ROSS BULLOCK REMODEL
40 WEST RIVO ALTO DR.
MIAMI BEACH, FL. 33139

40 West Rivo Alto Droive
Building Dept. review reply

Please see below the comments, and our response to them.

S-1.0

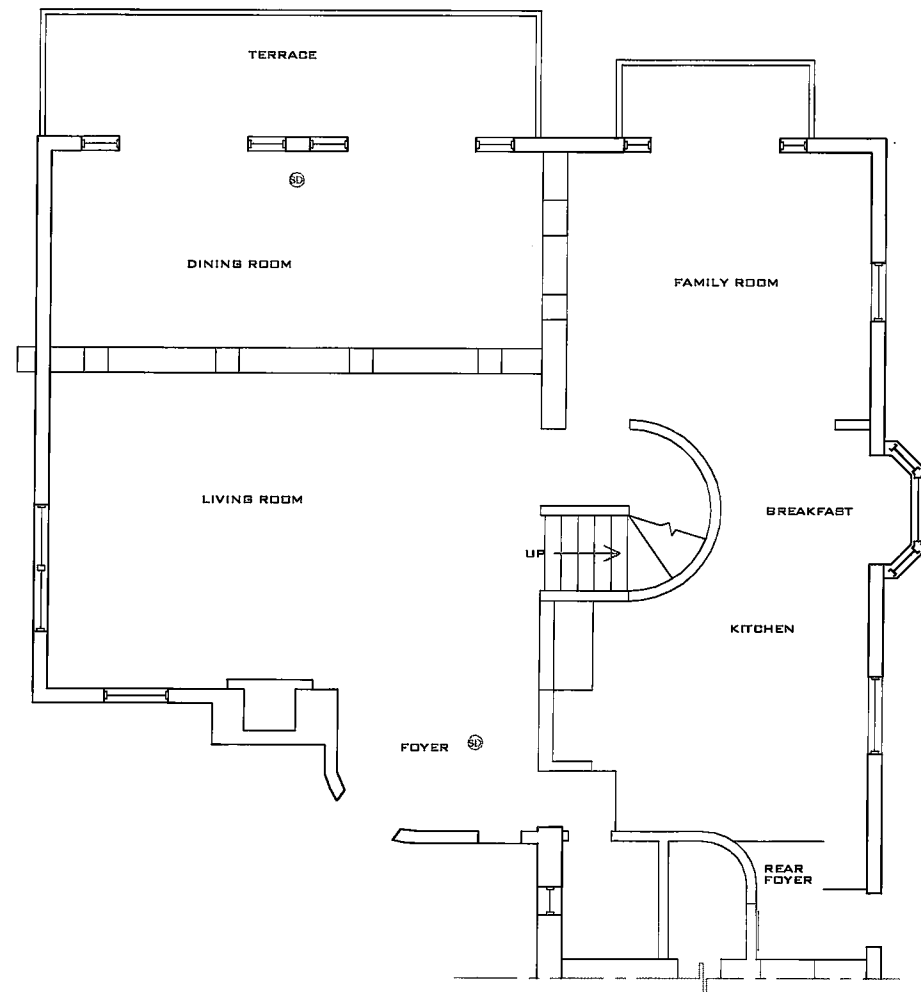
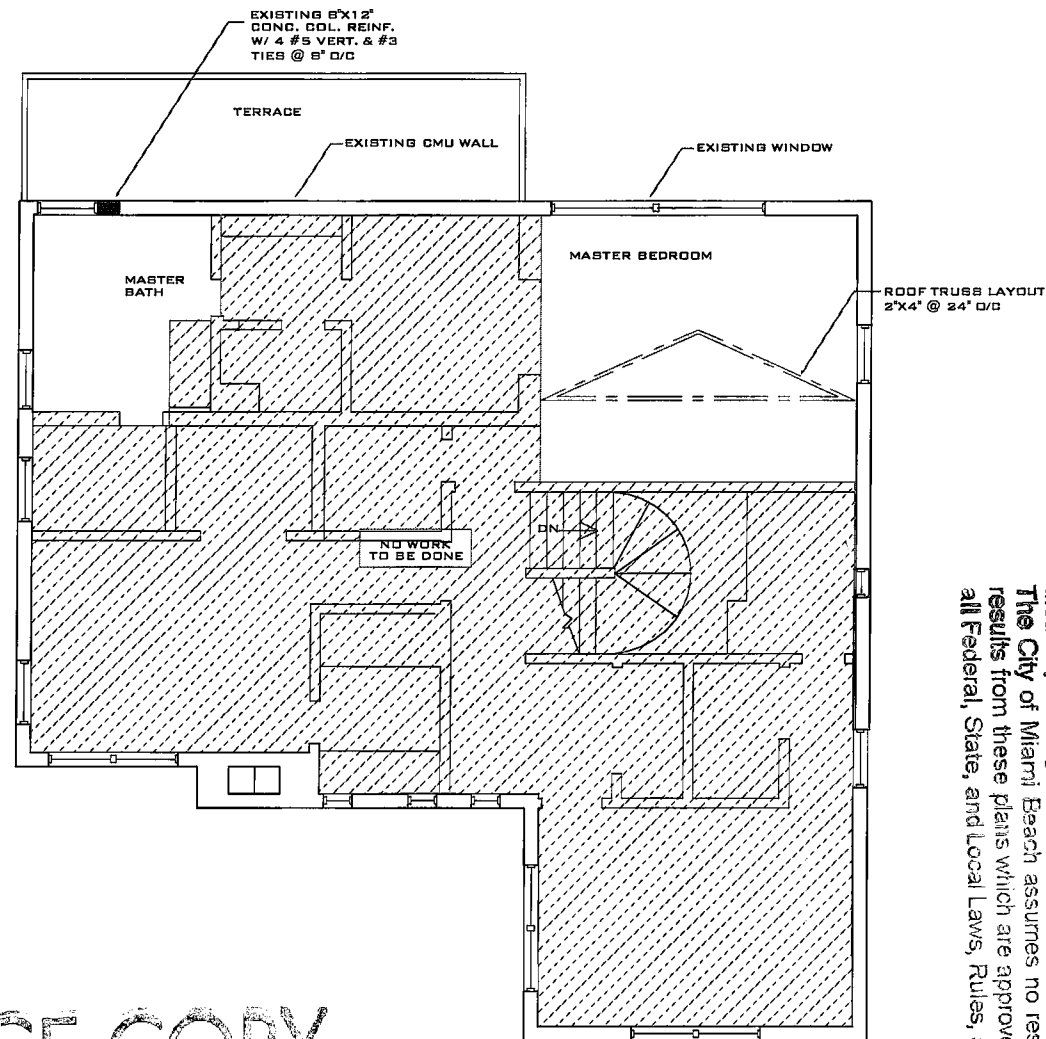
Previous comments on B1103334 remain: 1. Show existing floor and roof framing plan (at master bedroom)

REPLY: Please see sheet S1.0, existing plans for the house show that the west wall over the new opening is not load bearing. We could not locate the framing for the floor of the bedroom, but it does not effect any new elements.

SECTION 3
SCALE: 3/8"=1'-0" (S-2)

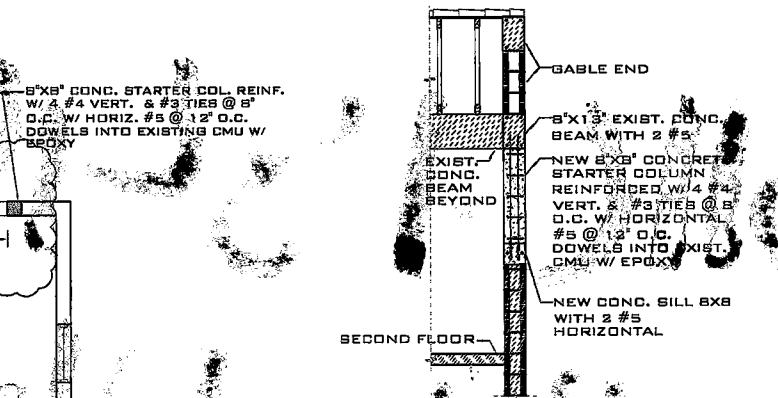
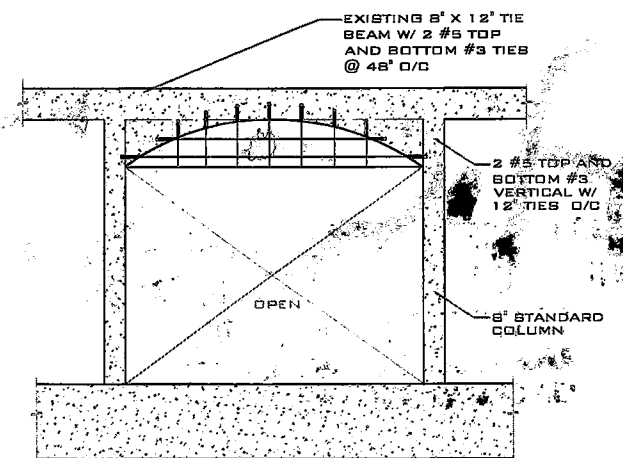
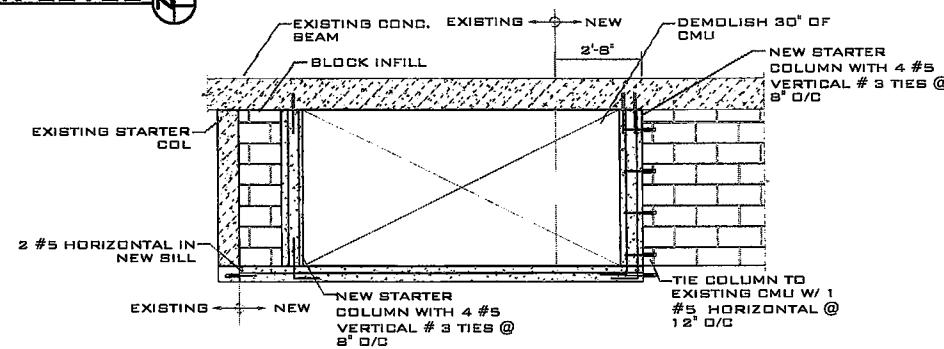
4. Coordinate detail A/A-1 with elevation. Note that elevation shows the closing of two arched door transoms.

REPLY: Please see attached sheet S-2, detail 1/S-2.
